Subdivision Application

· Ministry File # 12987

BARELAND STRATA OF LOT 2, DISTRICT LOT 11, NEWCASTLE DISTRICT, PLAN 34271

Re: Proposed Bare Land Strata Subdivision of Lot 2, District Lot 11, Newcastle District, Plan 34271.

TYPICAL HAMMERHEAD - GRAVEL

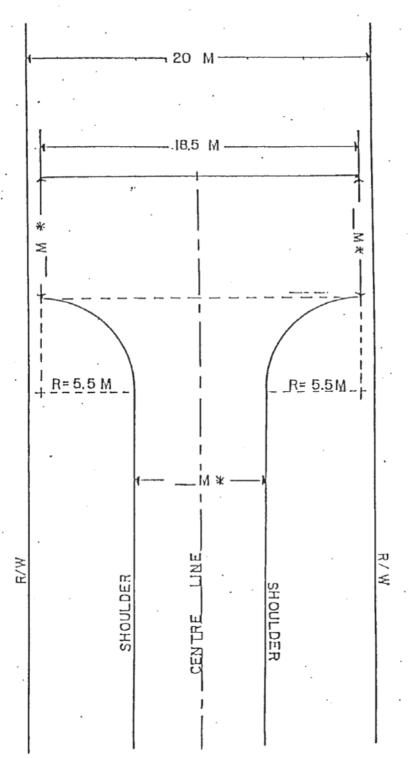
11.	Hammerhead requiredyes,no, and to be constructed as per attached sample drawing.
12.	Intersections - 6 metres x 6 metres corner cuts to be dedicated at all intersections, and road construction is to include 12 metre radius flares at all intersections unless otherwise noted.

TYPICAL HAMMERHEAD - GRAVEL

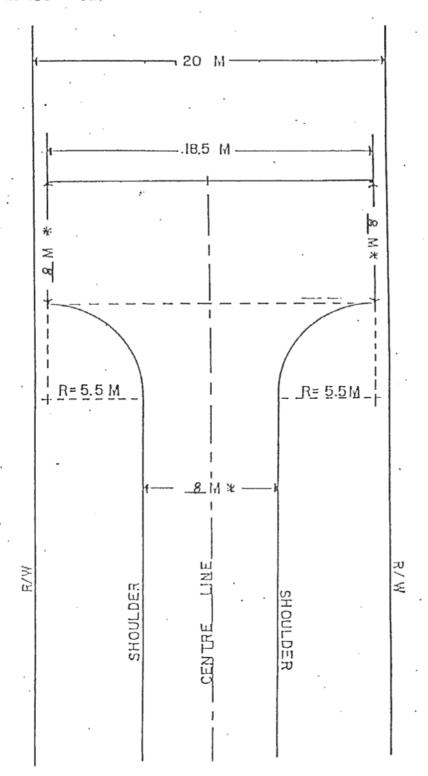
10.	Design Profile required
11.	Hammerhead requiredyes,no. and to be constructed as per attached sample drawing.
12.	Intersections -6 metres x 6 metres corner cuts to be dedicated at all intersections, and road construction is to include 12 metre radius flares at all intersections unless otherwise noted.
